REMARKS

Reconsideration of this application as amended is requested. By this amendment Applicant has amended the specification at pages 5 and 8 to correct obvious typographical errors, has amended Fig. 2 of the drawing to change the numeral "54" to "53" as indicated in red on Attachment 1, and has amended claims 1-4, 11 and 13. Claims 1-13 remain in the case.

FIG.2

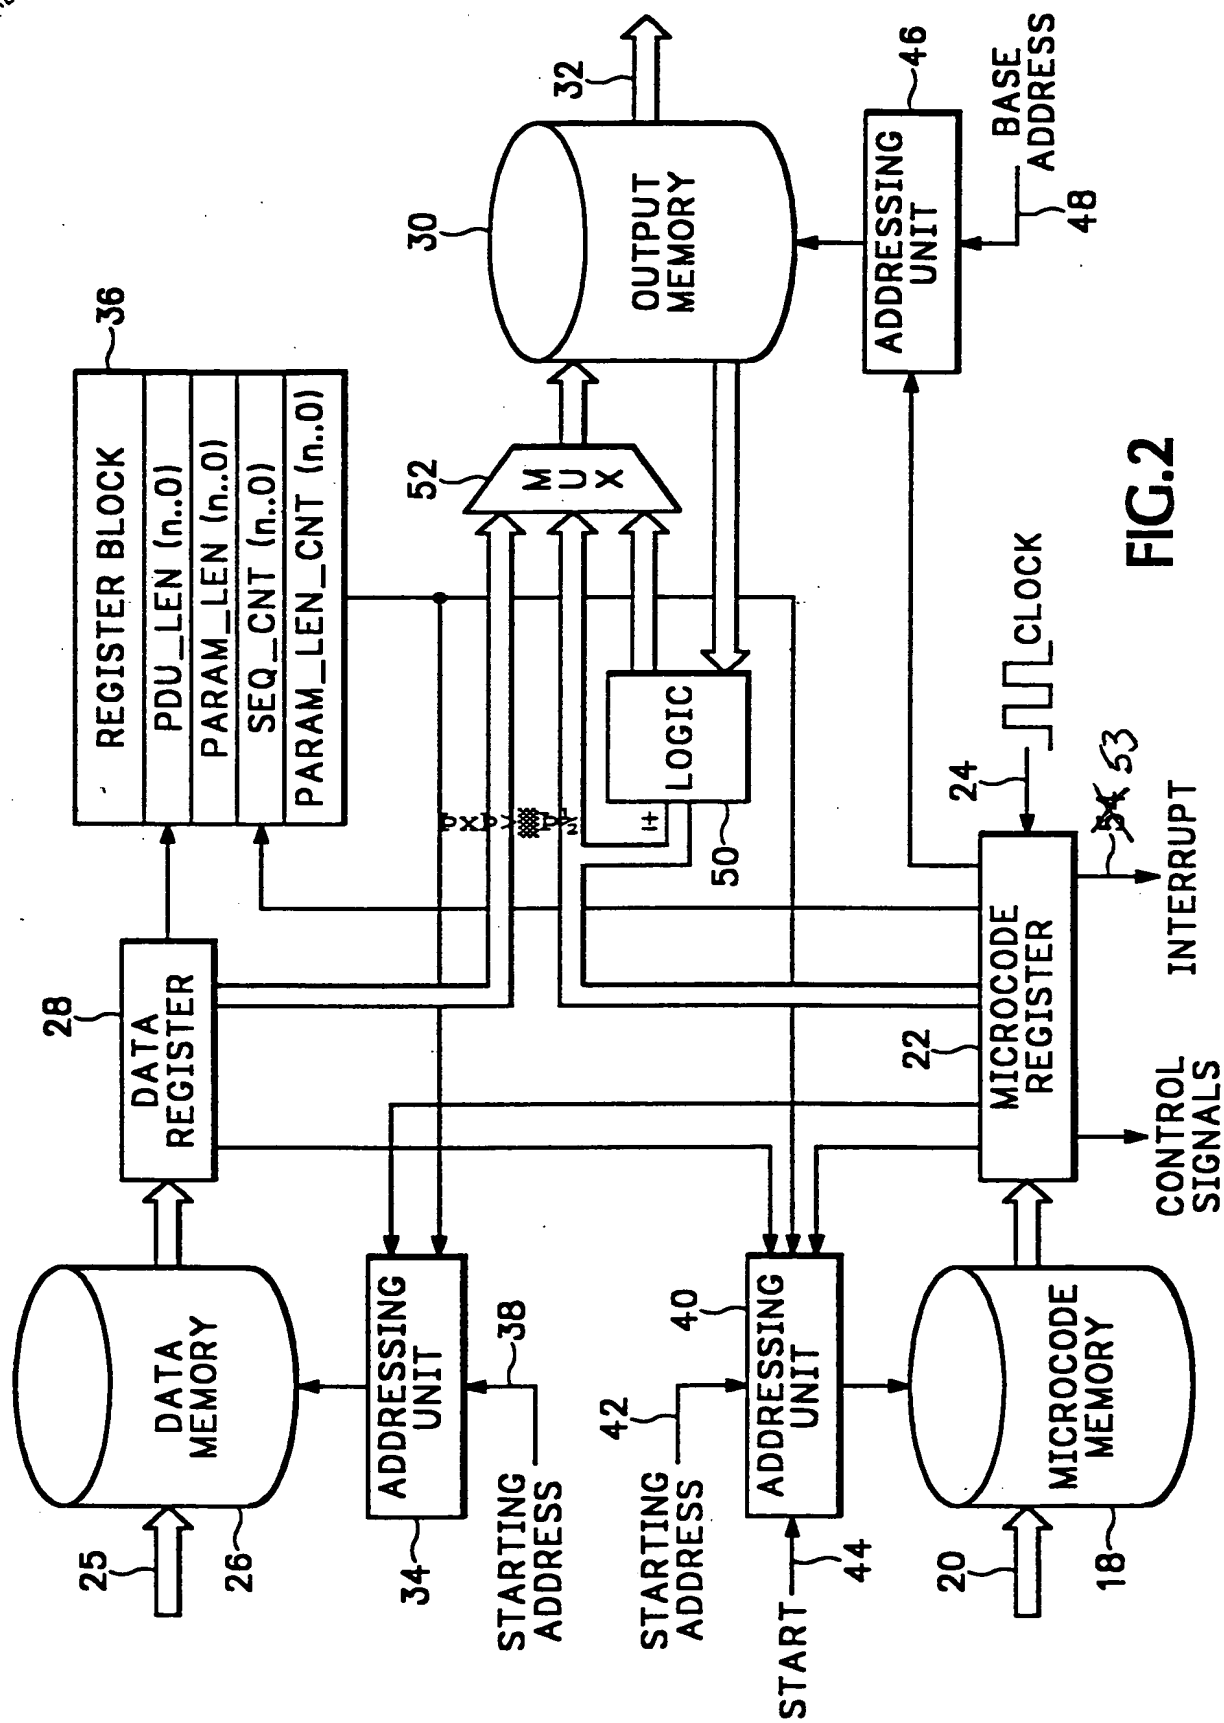
The Examiner objected to the drawing because Fig. 2 did not show "output 53" as referenced on lines 20 and 23 of page 8. As indicated above, a proposed drawing correction for Fig. 2 – replacing "54" with "53" – remedies this problem, rendering the Examiner's objection moot.
